**Addendum No: Four (4)**

**Project: College Oaks Elementary – Hurricane Laura Repairs**

**Architect's Project No: HL-010-01**

**Date: January 21, 2021**

**A3.2**  
SHEET  
REVISED  
ADDENDUM NO. 4  
1-21-2021

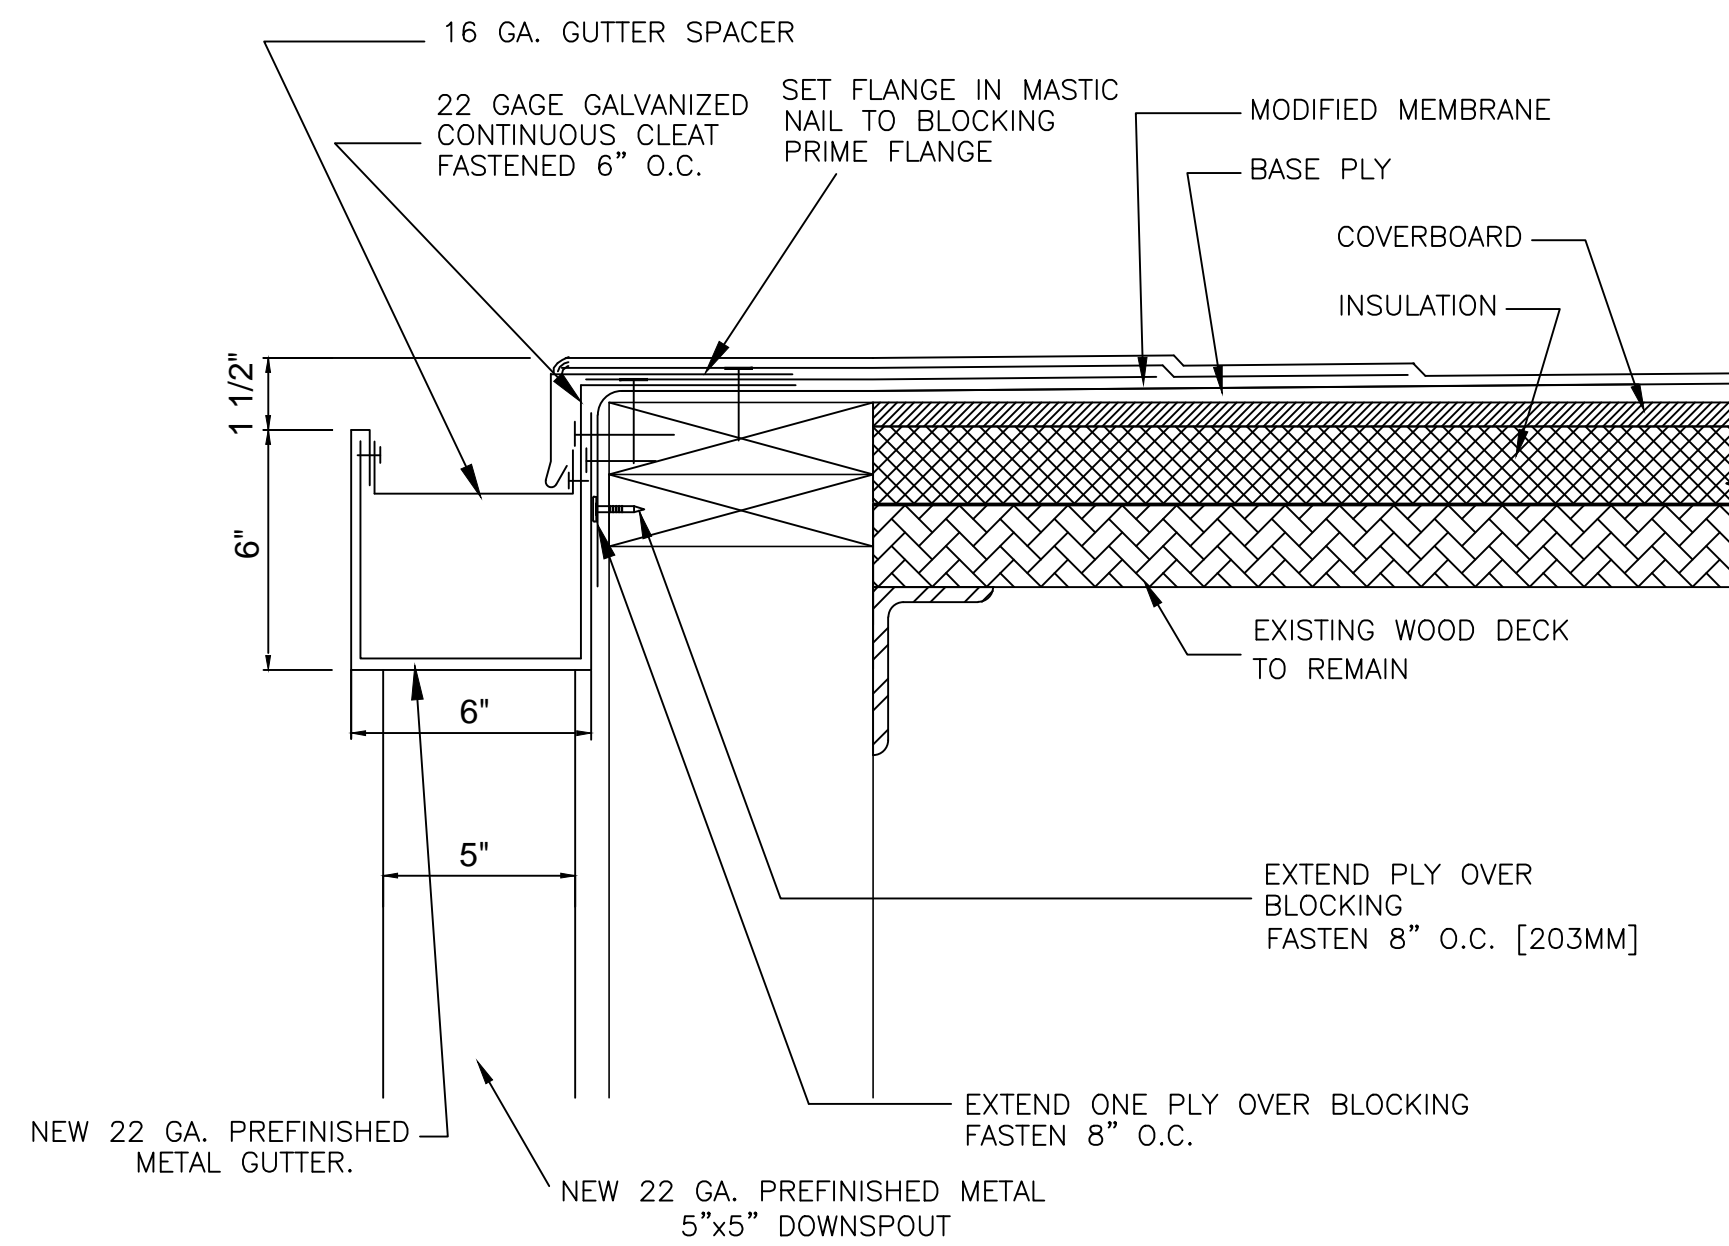
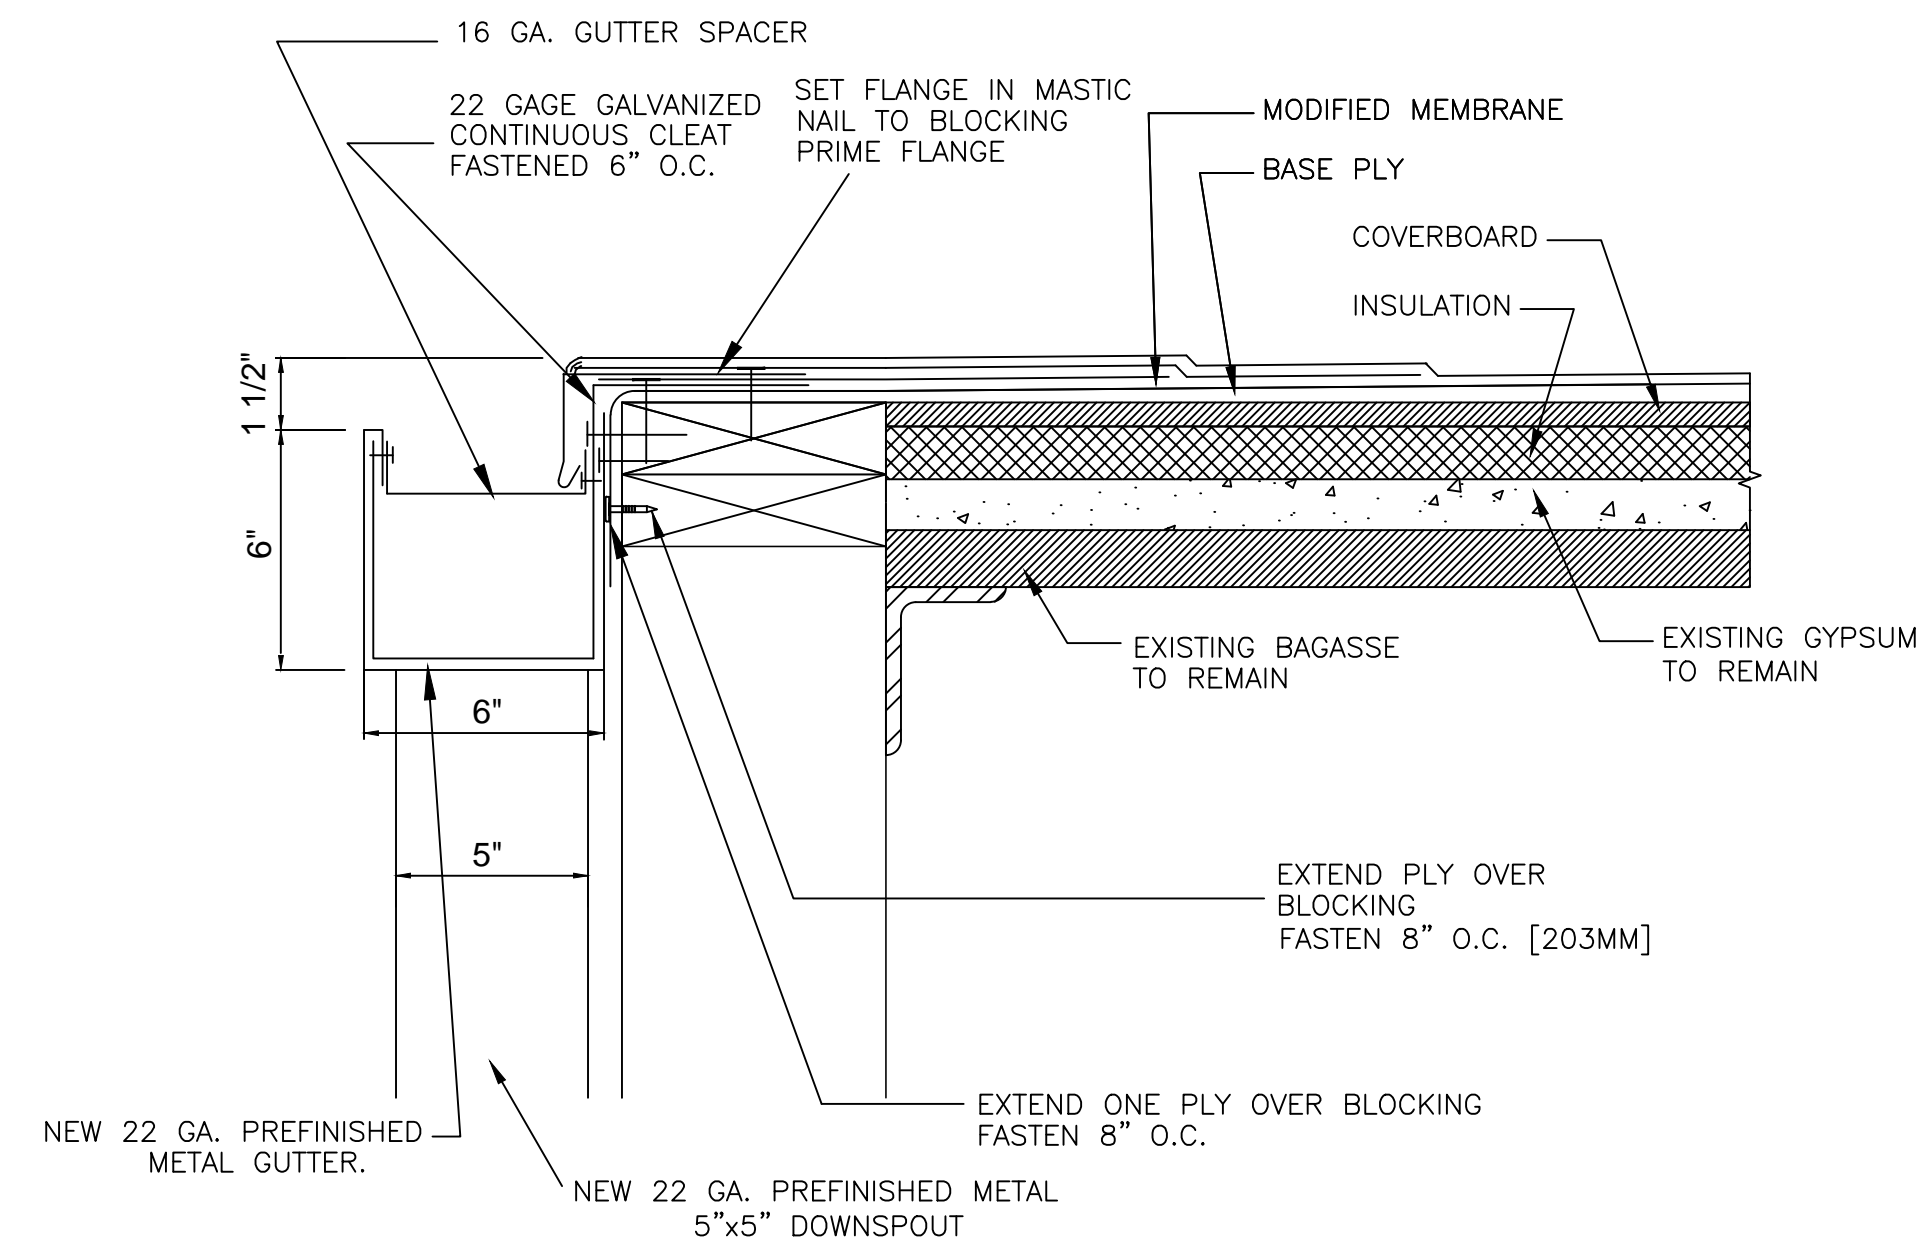
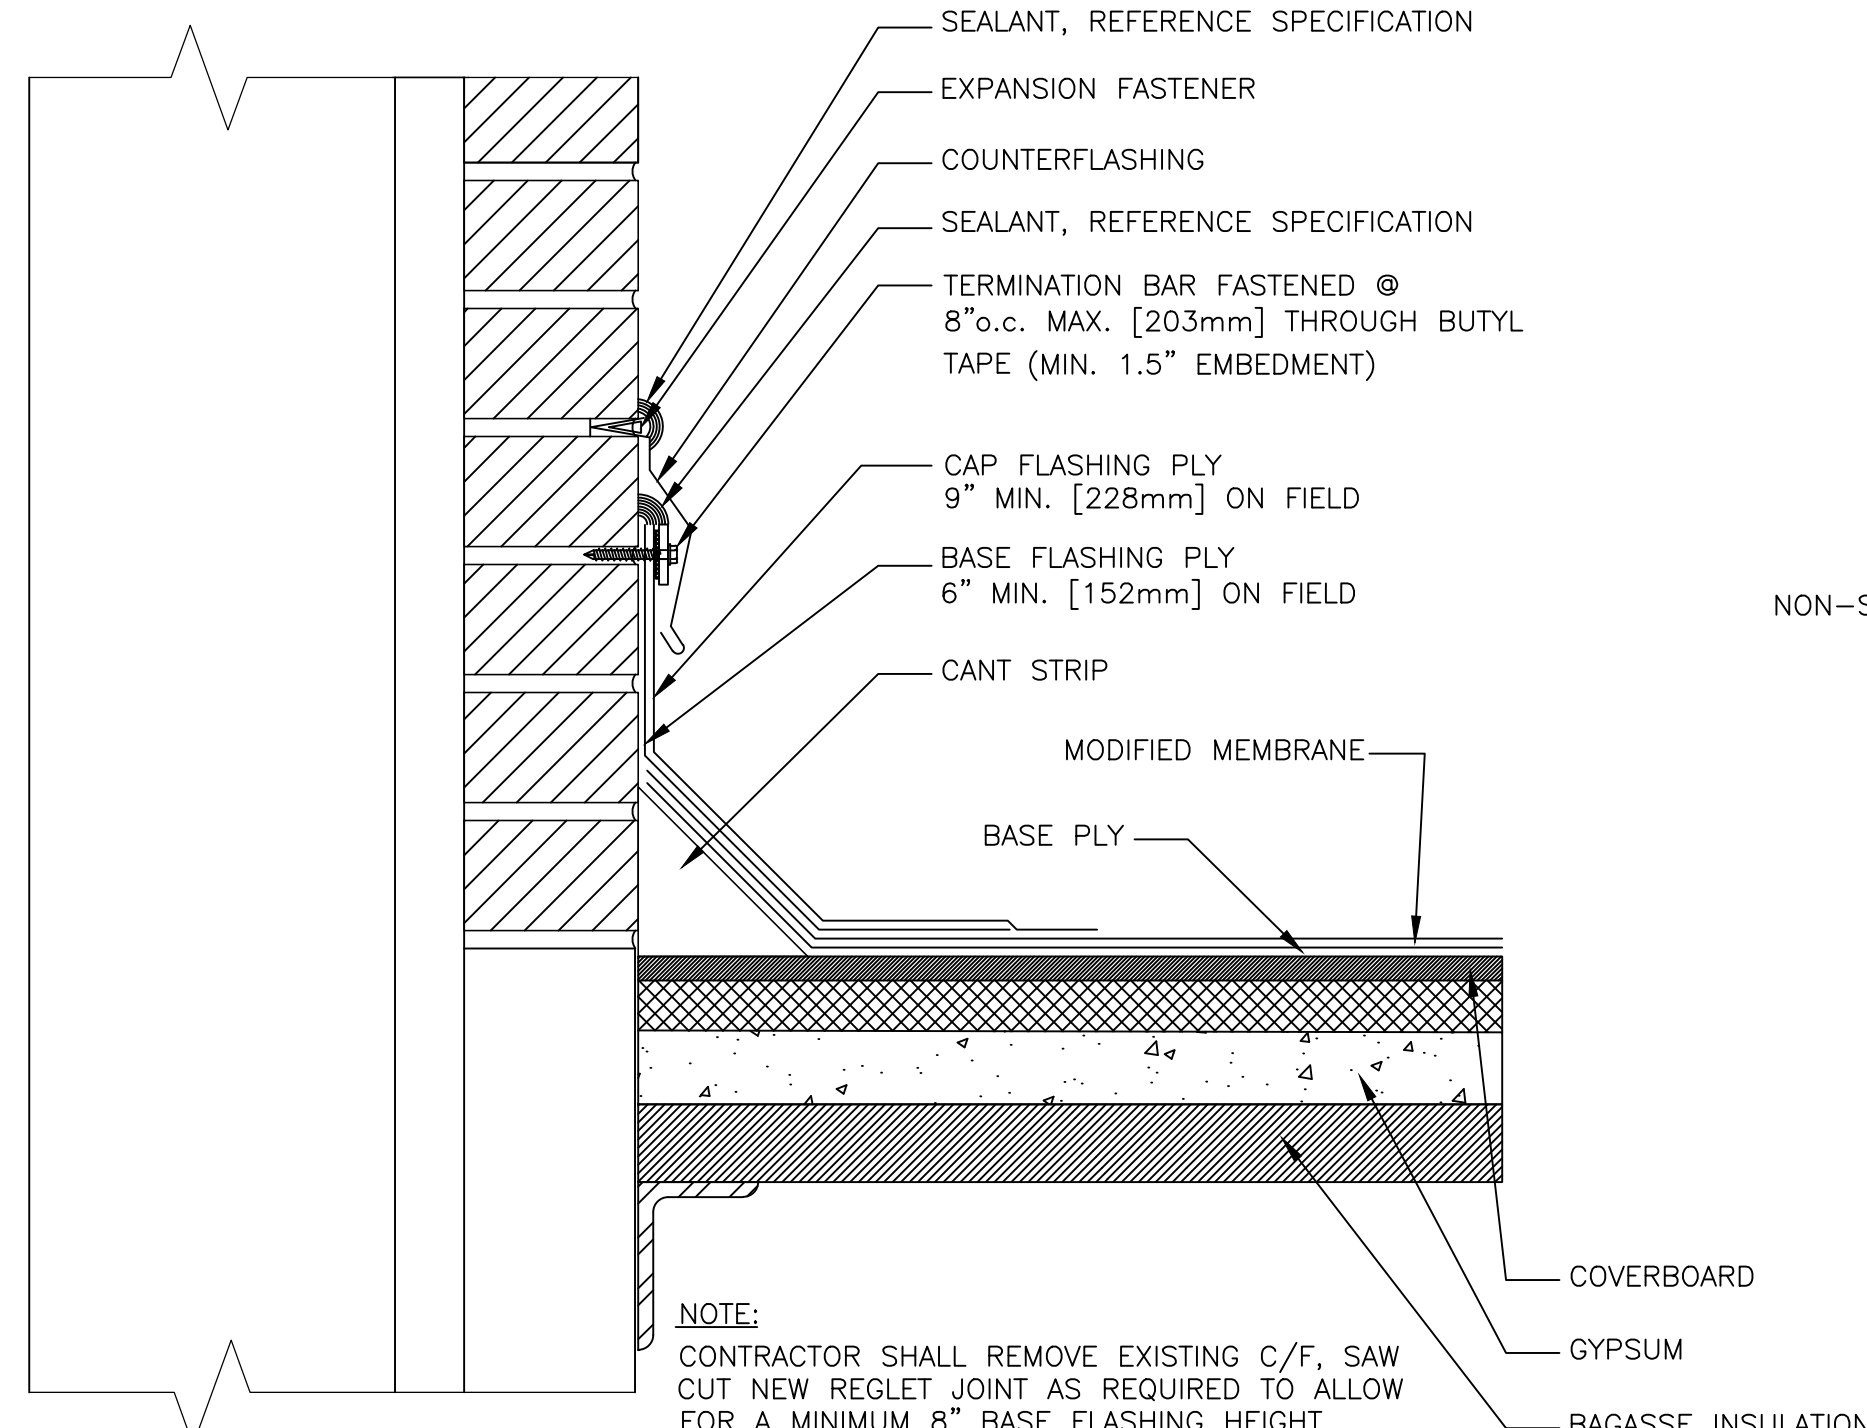
- 7) Sheet A3.1 – Remove existing and replace with revised (See Attached)
- 8) Sheet A3.2 – Remove existing and replace with revised (See Attached)
- 9) Sheets A1.1 & A2.1 – Regarding two (2) temporary buildings to the south of classroom 167 – Contractor shall remove and replace the existing ceiling grid and ceiling tile with new in both (32' x 32') buildings. New ceiling tile shall be Armstrong 1728A 2x2 or approved equal. Contractor shall remove (3' x 3') broken glass window and replace with new. Seal to existing window frame.
- 10) Sheet MP1.1 – Remove and replace with revised (See Attached)
